MFN 08-340

Docket No. 52-010

Subject: **Response to Portion of NRC Request for Additional Information Letter No. 106 - Related to ESBWR Design Certification Application – RAI Number 21.6-65 Supplement 1**

RAI Number 21.6-65 S01

Figure 1. IICI Hot Bundle #2400 CPR

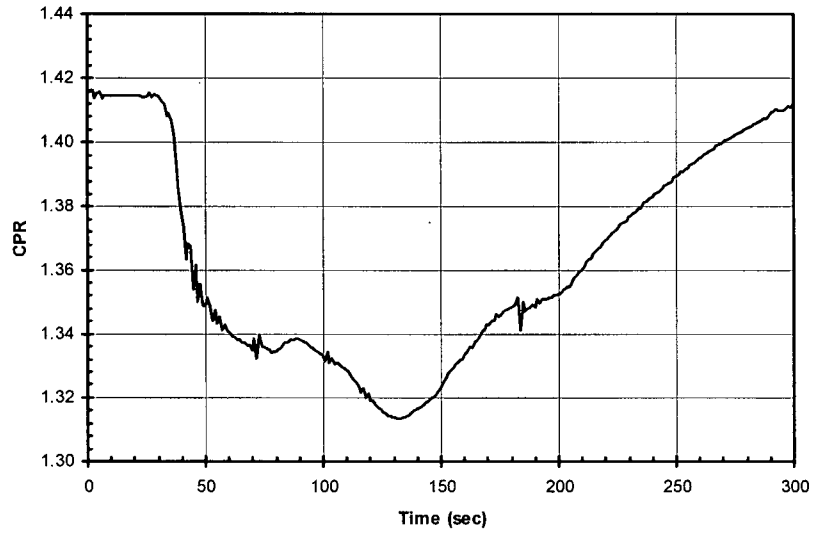
How are the channels selected for evaluating the maximum deltaCPR/ICPR that is used to determine the OLMCPR? Do you use the hot channel every time? Or do you take the maximum of all the channel groups? The staff is concerned for cold water injection events where although the Ring 3 channels (peripheral channels) do not have a hot channel, it is possible that these channel groups may experience the highest deltaCPR/ICPR.

The licensing criterion to be satisfied is that less than 0.1% of the fuel rods are expected to experience a boiling transition for the most severe AOO. Since the core MCPR always occurs in the hottest channels, the Δ CPR/ICPR of the hot channels are selected for the determination of OLMCPR.

TRACG calculation comparisons in Table 1 show that although the decrease in Δ CPR/ICPR of the peripheral channel (#341) in Ring 3 is greater than the hottest bundle (#2400) in Ring 2 for an IICI (Inadvertent Isolation Condenser Initiation) event in DCD Tier 2 Chapter 15 and in Ref. [2]; the Minimum Critical Power Ratio (MCPR) of the hot channel is much lower than the peripheral channel (Figures 1 and 2).

Therefore, the method for calculating OLMCPR is not affected by the fact that the Δ CPR/ICPR of the peripheral channel is higher than the interior channel in the cold water injection events, because the MCPR of the hot channel is substantially lower than that of the peripheral channel.
